WORKING GROUP REPORT

Power Park Modules and Synchronous Generating Units Working Group

**Prepared by the Power Park Modules and
Synchronous Generating Units Working Group
for submission to the Grid Code Review Panel**

Reference	PPMSGUWG Report
Issue	1.0
Date of Issue	9 th November 2006
Prepared by	PPMSGUWG

User's System Layout

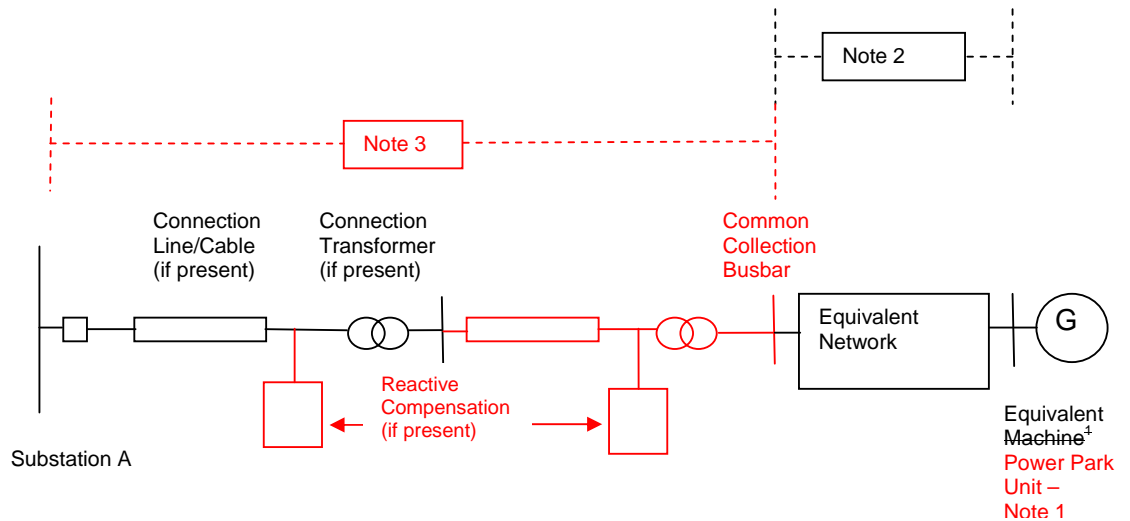
- 3) All **Plant** and **Apparatus** including the circuit breakers, transformers, lines, cables and reactive compensation plant between the **Common Collection Busbar** and Substation A shall be shown.

Figure CC.A.7.2.2b

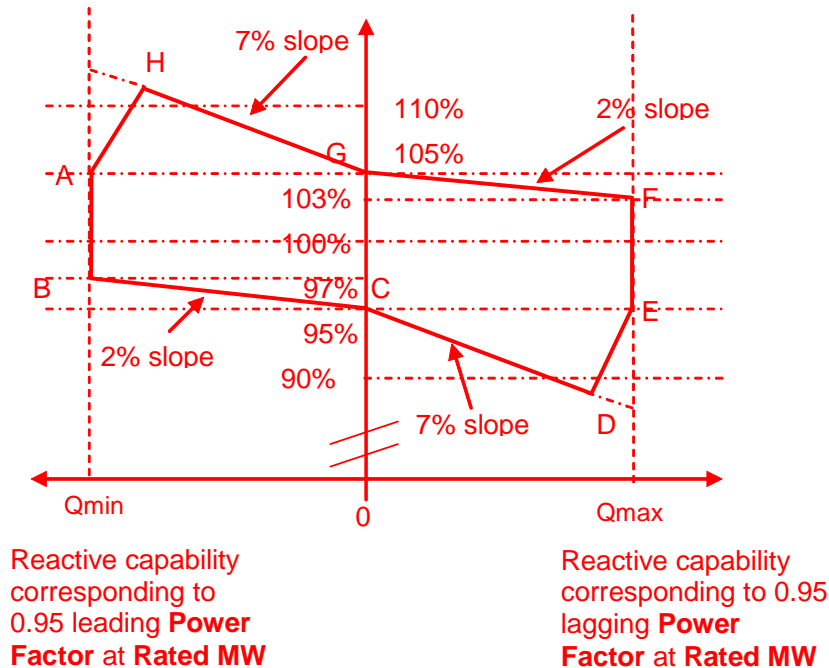
- CC.A.7.2.2.4 Figure CC.A.7.2.2b shows the required envelope of operation. The enclosed area within points ABCDEFGH is the required capability range of the **Non-Synchronous Generating Unit, DC Converter or Power Park Module** within which the **Slope** and **Setpoint Voltage** can be changed.

- CC.A.7.2.2.6 Should the **Reactive Power** output of the **Non-Synchronous Generating Unit, DC Converter or Power Park Module** reach its maximum lagging limit at a **Grid Entry Point voltage (or User System Entry Point voltage if Embedded)** above 95%, the **Non-Synchronous Generating Unit, DC Converter or Power Park Module** shall maintain maximum lagging **Reactive Power** output for voltage reductions down to 95%. This requirement is indicated by the line EF in figure CC.A.7.2.2b. Should the **Reactive Power** output of the **Non-Synchronous Generating Unit, DC Converter or Power Park Module** reach its maximum leading limit at a **Grid Entry Point voltage (or User System Entry Point voltage if Embedded)** below 105%, the **Non-Synchronous Generating Unit, DC Converter or Power Park Module** shall maintain maximum leading **Reactive Power** output for voltage increases up to 105%. This requirement is indicated by the line AB in figure CC.A.7.2.2b.

from the supply of maximum lagging reactive current whilst ensuring the current remains within design operating limits. An example of the capability is shown by the line DE in figure CC.A.7.2.2b. For **Grid Entry Point** voltages (or **User System Entry Point** voltages if **Embedded**) above 105%, the leading **Reactive Power** capability of the **Non-Synchronous Generating Unit, DC Converter or Power Park Module** should be that which results from the supply of maximum leading reactive current whilst ensuring the current remains within design operating limits. An example of the capability is shown by the line AH in figure CC.A.7.2.2b. Should the **Reactive Power** output of the **Non-Synchronous Generating Unit, DC Converter or Power Park Module** reach its maximum lagging limit at a **Grid Entry Point** voltage (or **User System Entry Point** voltage if **Embedded**) below 95%, the **Non-Synchronous Generating Unit, DC Converter or Power Park Module** shall maintain maximum lagging reactive current output for further voltage decreases. Should the **Reactive Power** output of the **Non-Synchronous Generating Unit, DC Converter or Power Park Module** reach its maximum leading limit at a **Grid Entry Point** voltage (or **User System Entry Point** voltage if **Embedded**) above 105%, the **Non-Synchronous Generating Unit, DC Converter or Power Park Module** shall maintain maximum leading **Reactive Power** output for further voltage increases.

Figure CC.A.3.2 - Interpretation of Primary and Secondary Response Values

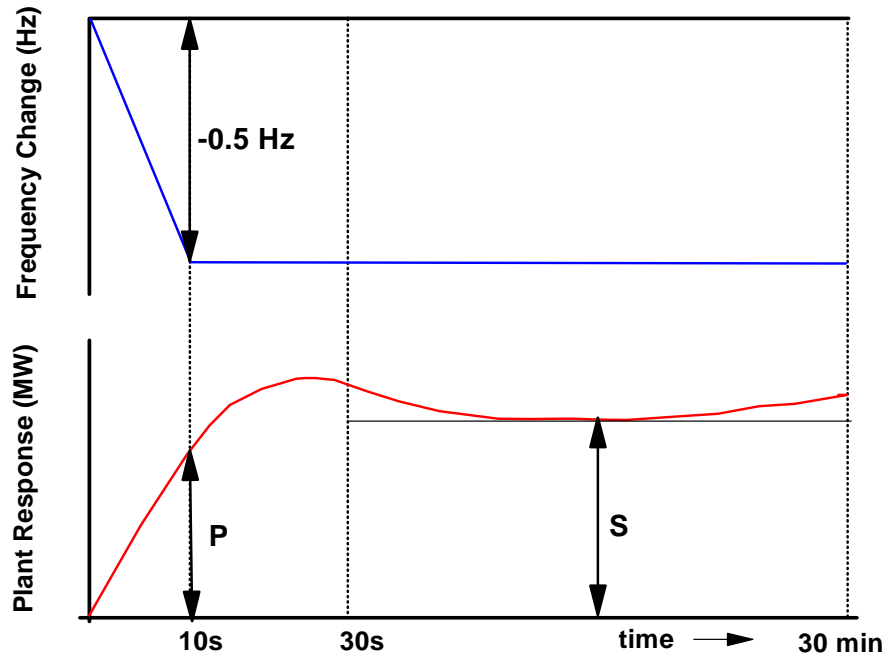
The **Primary Response** capability (P) of a **Generating Unit** or a **CCGT Module** or **Power Park Module** or **DC Converter** is the minimum increase in **Active Power** output between 10 and 30 seconds after the start of the ramp injection as illustrated diagrammatically in Figure CC.A.3.2. This increase in Active Power output should be released increasingly with time over the period 0 to 10 seconds from the time of the start of the Frequency fall as illustrated by the response in Figure CC.A.3.2.

The **Secondary Response** capability (S) of a **Generating Unit** or a **CCGT Module** or **Power Park Module** or **DC Converter** is the minimum increase in **Active Power** output between 30 seconds and 30 minutes after the start of the ramp injection as illustrated diagrammatically in Figure CC.A.3.2.

Figure CC.A.3.3 - Interpretation of High Frequency Response Values

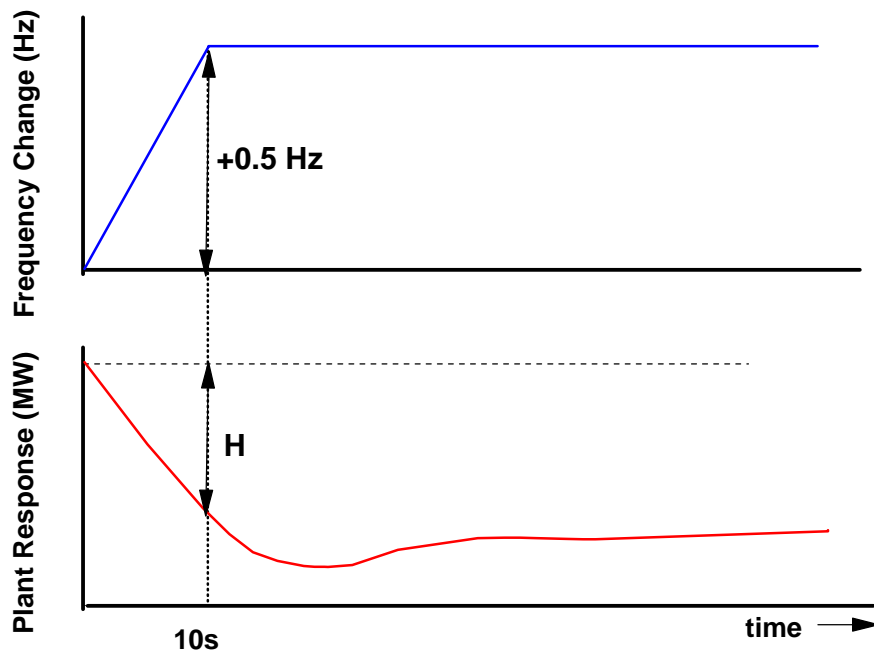
The **High Frequency Response** capability (H) of a **Generating Unit** or a **CCGT Module** or **Power Park Module** or **DC Converter** is the decrease in **Active Power** output provided 10 seconds after the start of the ramp injection and

sustained thereafter as illustrated diagrammatically in Figure CC.A.3.3. This reduction in **Active Power** output should be released increasingly with time over the period 0 to 10 seconds from the time of the start of the **Frequency** rise as illustrated by the response in Figure CC.A.3.2.
